IN THE MATTER OF AN APPLICATION TO
AN BORD PLEANÁLA
FOR PERMISSION FOR
STRATEGIC INFRASTRUCTURE DEVELOPMENT
(THE CHILDREN'S HOSPITAL OF IRELAND)

ABP Reg. No. PL29N.PA0024

Statement of Evidence of Paul Healy, O'Connor Sutton
Cronin Consulting Engineers

On the Topic of Civil & Structural Engineering

Layout of existing drainage network

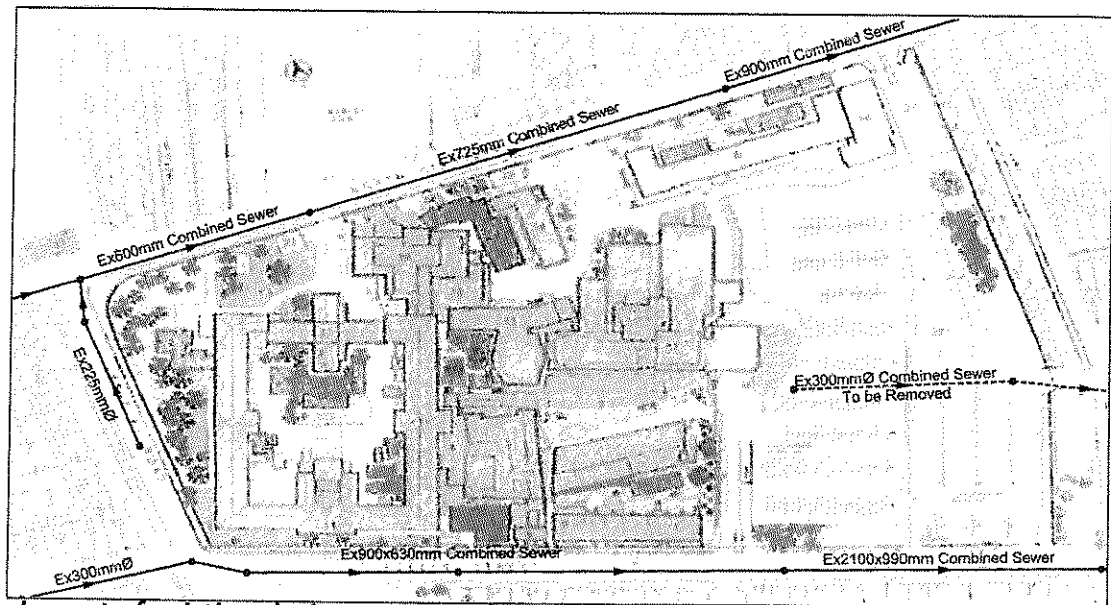
Discharge of the foul sewage into combined sewer on North Circular Road.

“One of the most disturbing aspects of the EIS is the acceptance of the report that the discharge of the foul sewage from the development into a combined sewer on North Circular Road. This is a practise that is inconsistent with proper management of the drainage from the site.....”

We wish to advise the Board that this submission is totally incorrect. In fact, discharge of foul sewage to the combined sewer system is the usual and most appropriate system to discharge into. We would additionally add that as noted in our statement above, under the operational phase of this development, the combined sewer in North Circular Road will be relieved of flow during periods of otherwise peak flows.
